Parish Hall Package B
Our Lady of Victory - Diocese of Victoria
Project # 716-0114 B

ADDENDUM NUMBER TWO

April 29, 2016

PARISH HALL		Our Lady of Victory Catholic Church - Diocese of Victoria	
 Rawley McCoy & Associates, PLLC ARCHITECTS AND INTERIOR DESIGNERS	SHEET TITLE:	COUNSELING CENTER RCP	
	DATE:	04/29/16	REVISION TYPE:
	SCALE:	1" = 10'-0"	SHEET NO:
	PROJECT #:	716-0114B	BA3.1R1
		ADDENDUM 2

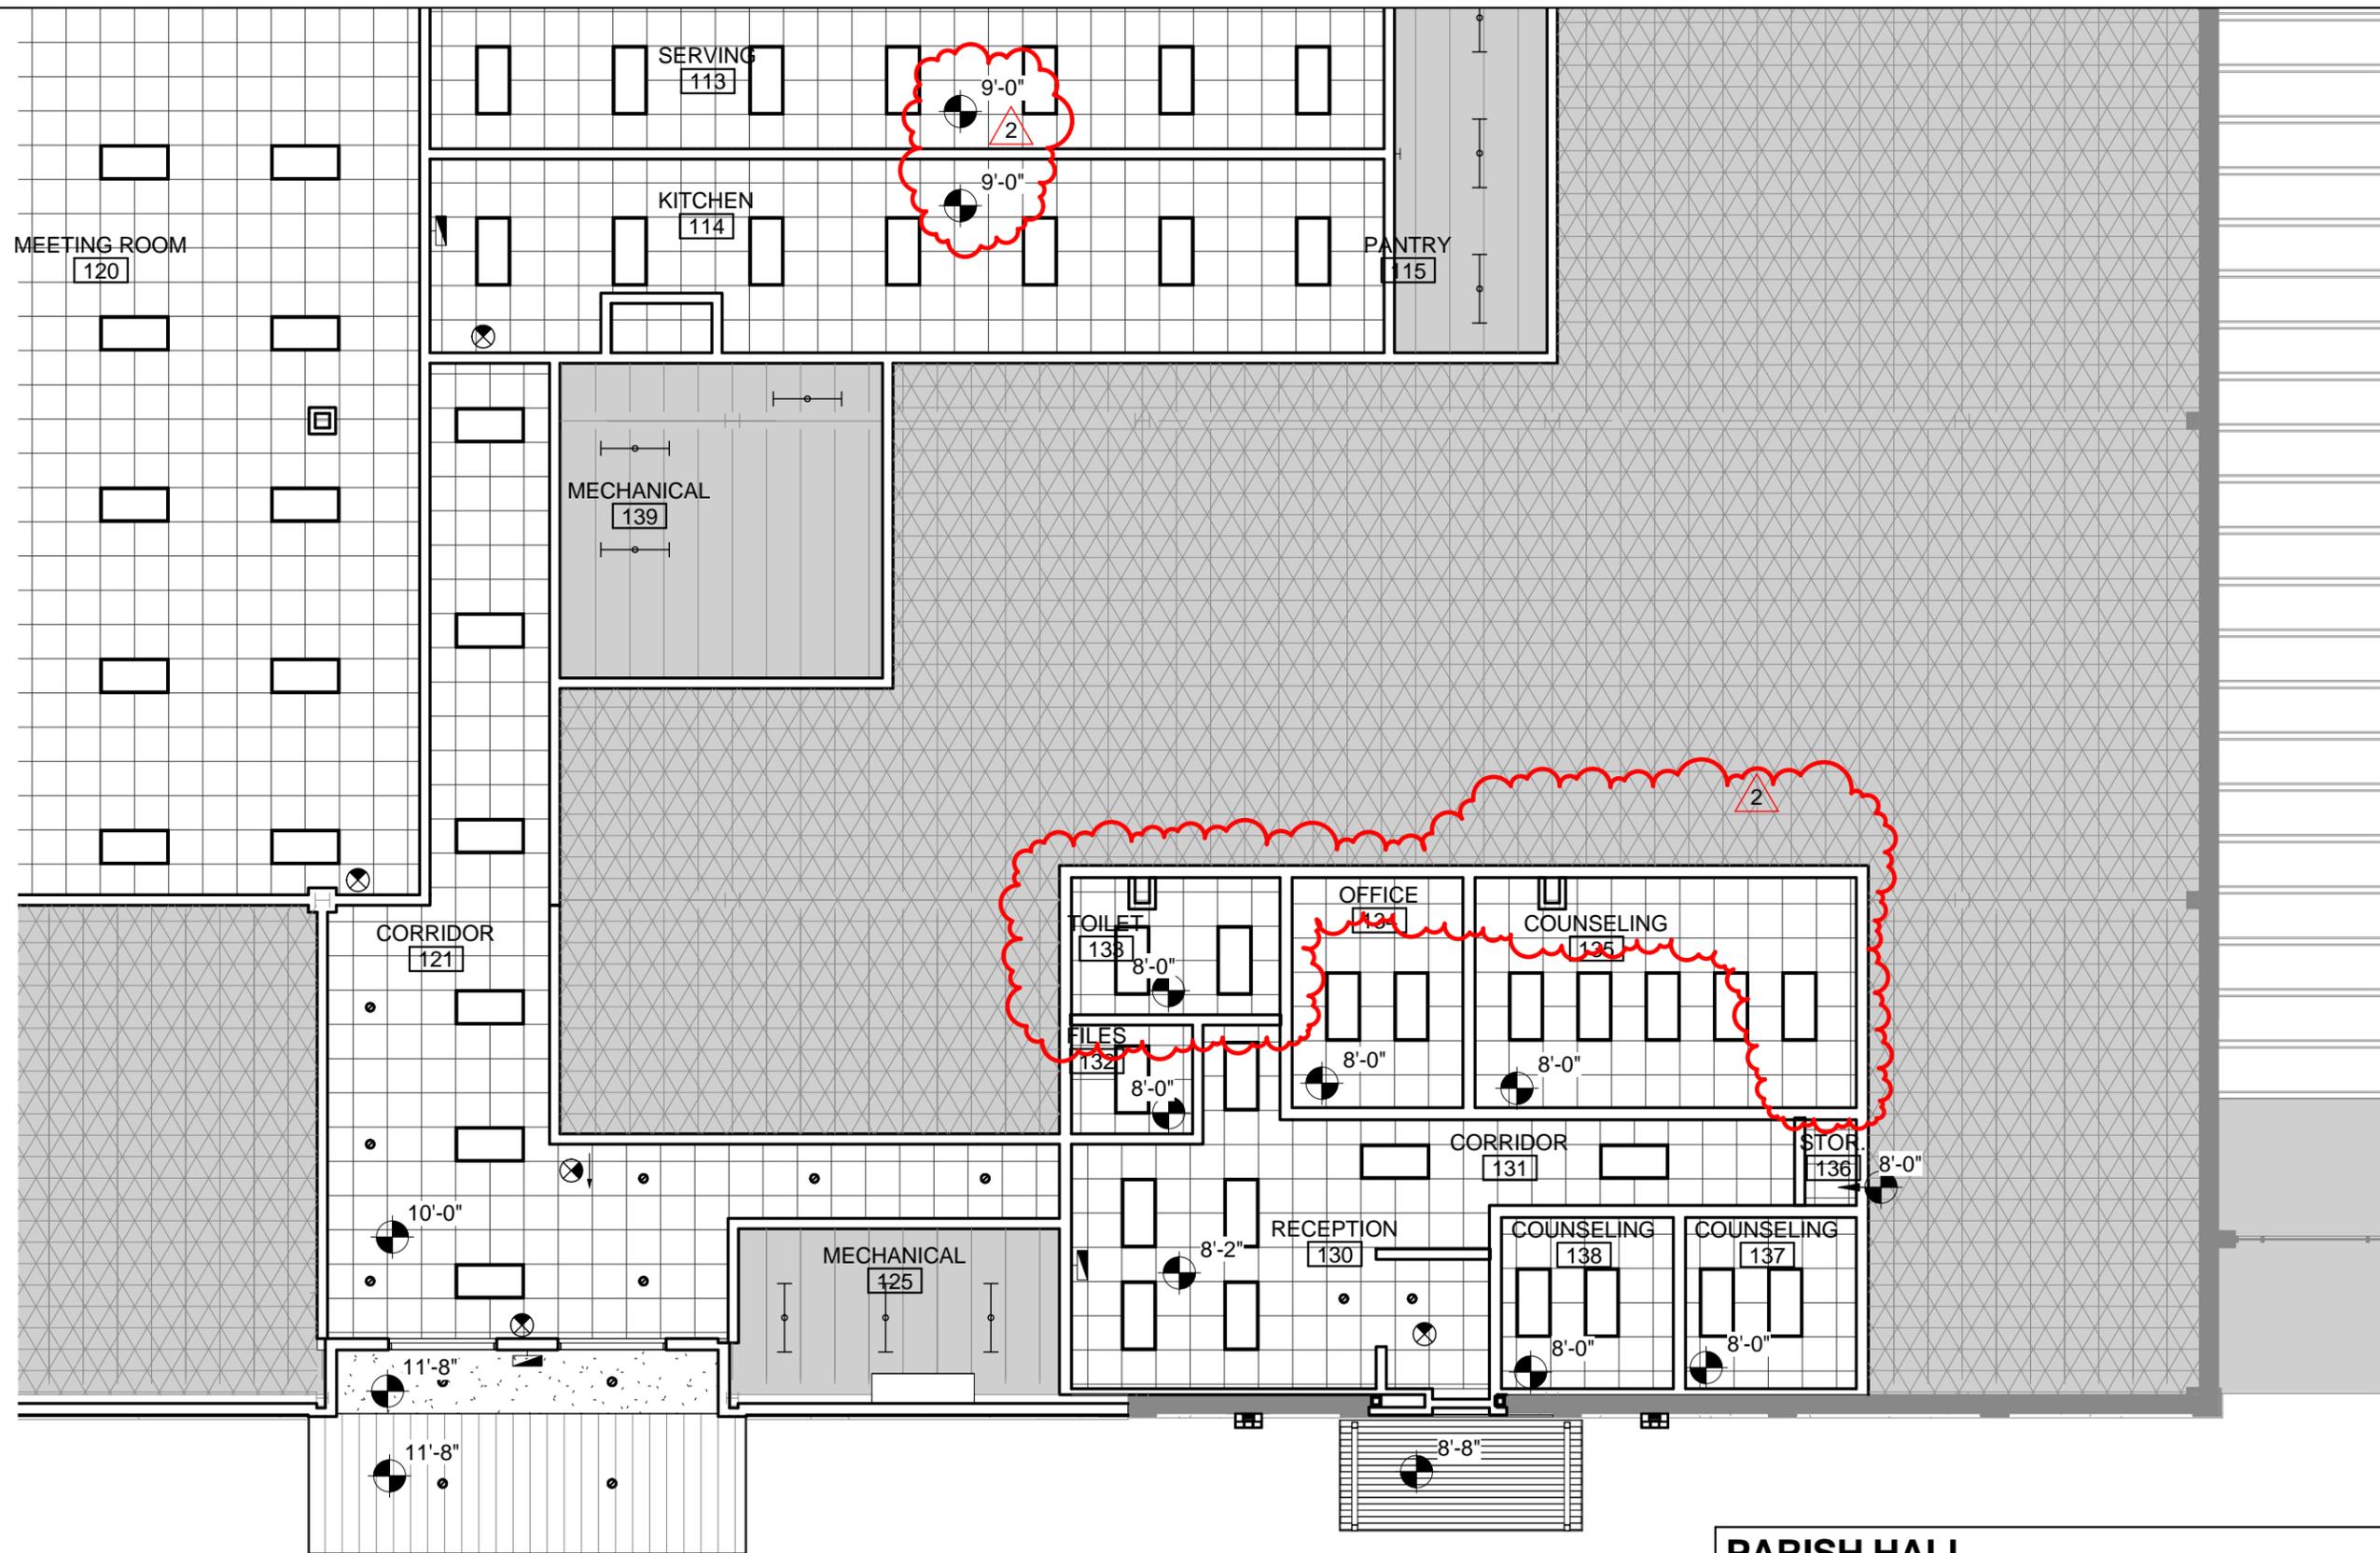
4. BA3.1R1 COUNSELING CENTER REFLECTED CEILING PLAN
Revision: **SEE ATTACHED**
Revised wall location
Enlarged rooms 133, 134 and 135
Room 113 and 114 ceiling heights

BA8.1R1

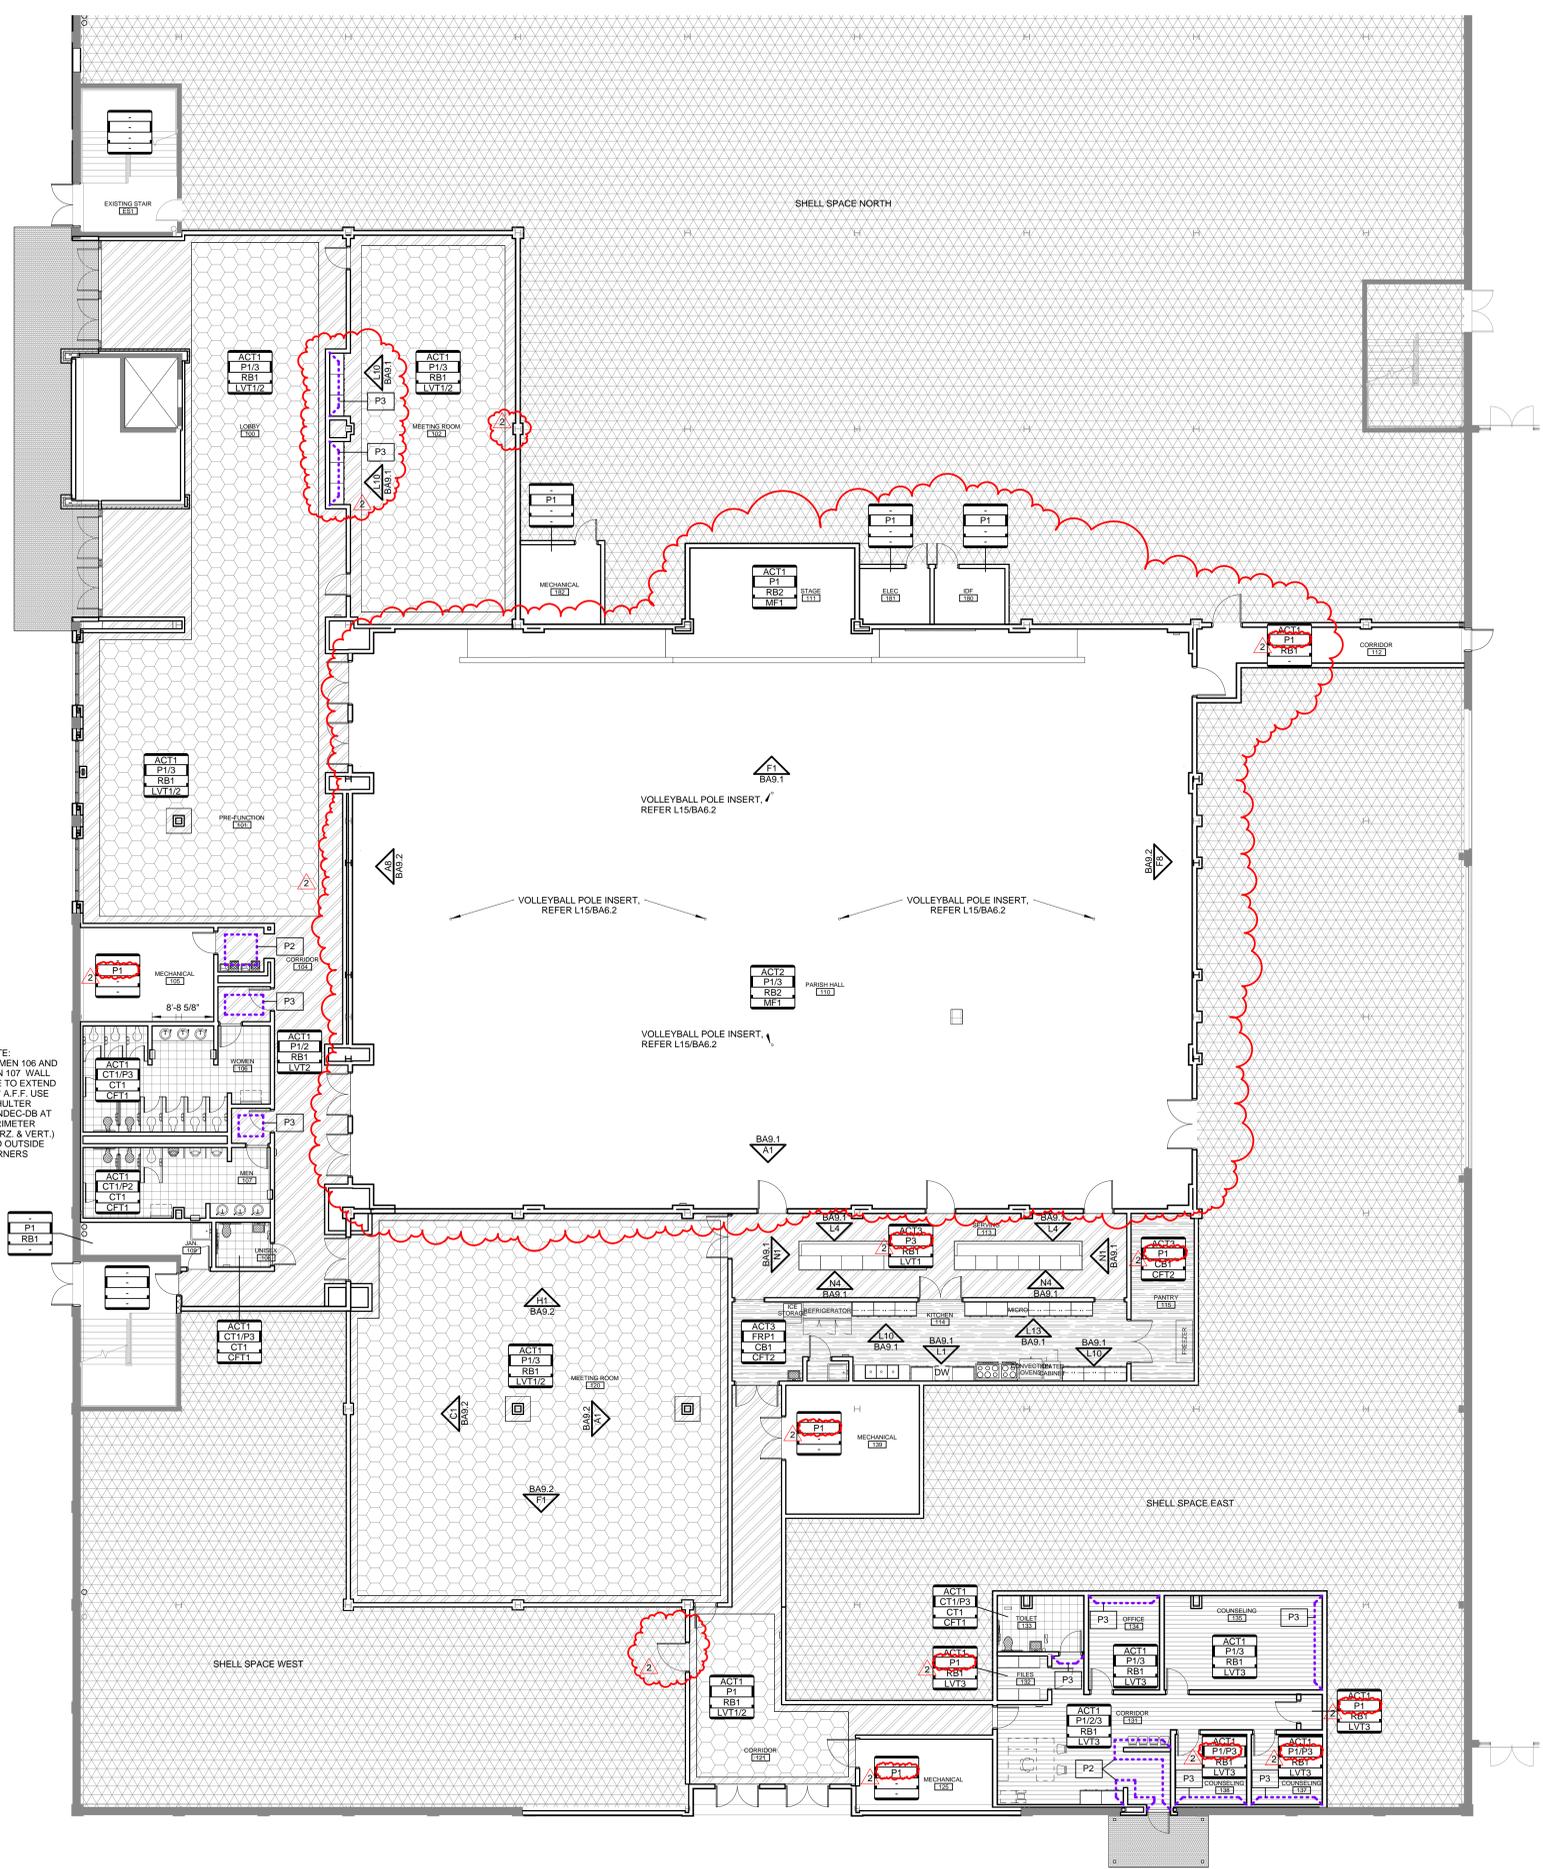
5. BA8.1R1 FINISH PLAN & MATERIAL SCHEDULE
Revision: **REPLACE** BA8.1 FINISH PLAN & MATERIAL SCHEDULE
WITH BA8.1R1 FINISH PLAN & MATERIAL SCHEDULE
Miscellaneous corrections to room finishes
No flooring in Parish Hall 110
Counseling Center layout changes

1. Toilet 133 – do all walls receive ceramic tile? Is the tile full height?
RMA: Yes, all walls receive tile. Tile to extend 4'-0" A.F.F., use Schulter Rondec-db at perimeter (horz. & vert.) and outside corners

2. Unisex 108 - do all walls receive ceramic tile? Is the tile full height?
RMA: Yes, all walls receive tile. Tile to extend 4'-0" A.F.F., use Schulter Rondec-db at perimeter (horz. & vert.) and outside corners

NOTE: WOMEN 106 AND MEN 107 WALL TILE TO EXTEND 4'-0" A.F.F. USE SCHULTER RONDEC-DB AT PERIMETER (HORZ & VERT.) AND OUTSIDE CORNERS
